Project Name: Elizabeth Trace
 Description: Amended preliminary and final site plan approval
 Date on Agenda this packet pertains to: March 6, 2025

RE: Elizabeth Trace- Preliminary and Final Site Plan Review – 2nd Review

**Combined Preliminary – Final Site Plan Review
for
White Lake Charter Township, Michigan**

Preliminary and Final Site Plan Review

TRANSFORMER SCREENING DETAIL

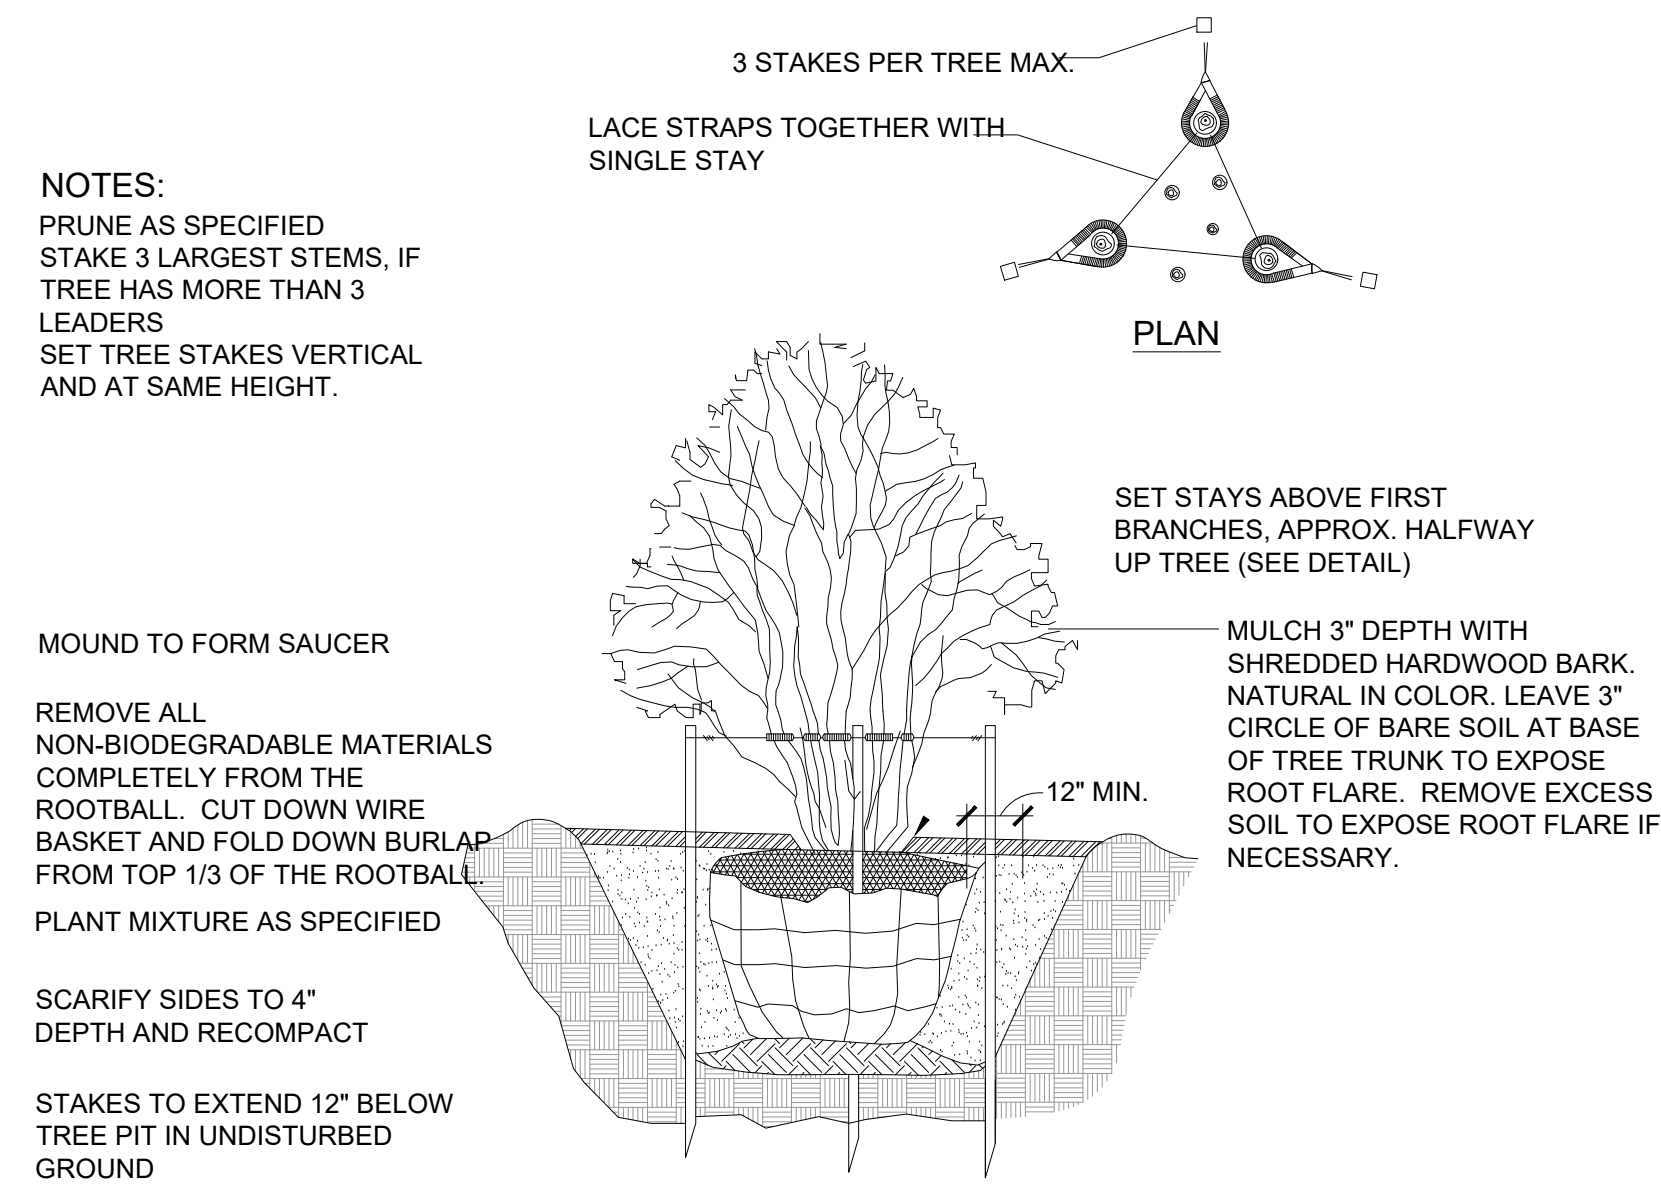
There are two (2) transformers on site. Sheet L-2 provides a plan showing the proposed transformer landscaping and eight (8) evergreen shrubs will be planted two (2) feet away from the transformers to provide screening. There is an optional row of four (4) evergreen shrubs planted eight (8) feet away from the transformers.
